**REBUTTAL TESTIMONY OF RICHARD KUPREWICZ  
EVALUATING PG&E'S PIPELINE SAFETY ENHANCEMENT  
PLAN**

**CALIFORNIA PUBLIC UTILITIES COMMISSION  
PIPELINE SAFETY RULEMAKING  
R. 11-02-019**

**Submitted on behalf of  
THE UTILITY REFORM NETWORK (TURN)**

5 Figure 1: Pressure Cycling, MAOP = 975 psig

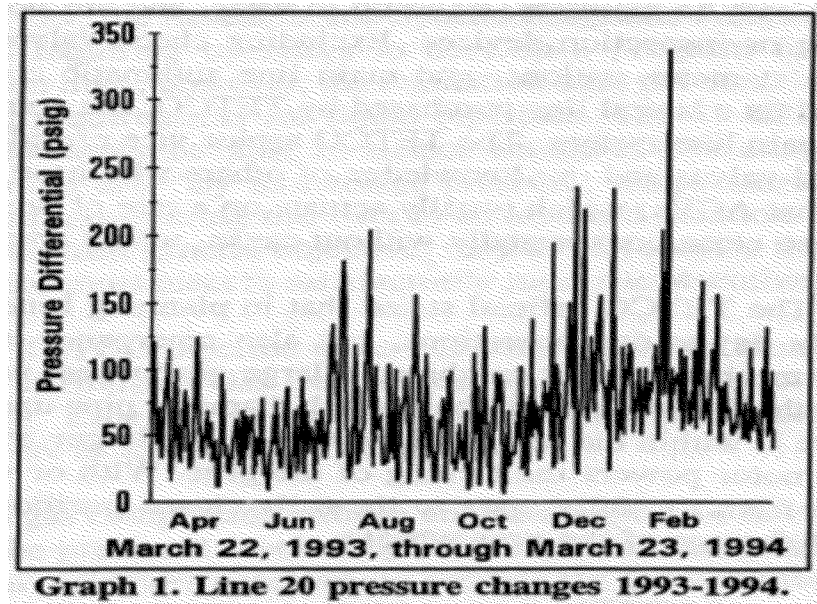
14 Low-pressure, low % SMYS, hydrotesting can leave very large imperfections in the  
15 manufactured pipe seam welds that are much more susceptible to further growth to rupture  
16 failure in a relatively short time from pressure cycling than the much smaller imperfections left  
17 in high-pressure hydrotesting. This is especially true on many gas transmission pipelines that  
18 undergo considerable variations in their operating pressure, which occurs on most gas  
19 transmission pipelines. It is a myth that gas transmission pipelines do not pressure cycle. Figure  
20 1 below is an example of a gas transmission pipeline pressure cycle spectrum (MAOP of 975

1 psig) in the public domain whose pipe ruptured from time -delayed damage many years after the  
2 damage occurred.<sup>1</sup>
